TECHNICAL INFORMATION

Subject ▶ Change of Spindle and Compression Spring 45,
Addition of Compression Spring 49 and Flat Washer 35

For Models ▶ TW1000

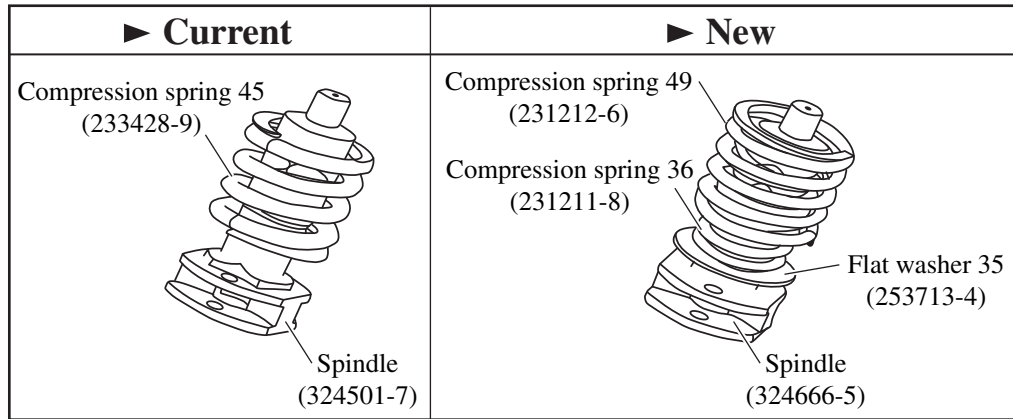
Description ▶ The components of Spindle section have been changed/ added as illustrated below for further improvement in durability of Hammer.

Item No.	Current part	Q'ty	I/C	New part	Q'ty	Note
013	Spindle ----- 324501-7	1	No	Spindle ----- 324666-5	1	The current parts remain available. Interchangeable as a set
010	Compression Spring 45 ----- 233428-9	1	No	Compression Spring 36 ----- 231211-8	1	
058	-----			Compression Spring 49 ----- 231212-6	1	
059	-----			Flat Washer 35 ----- 253713-4	1

From serial No. 24530E (October 2009)
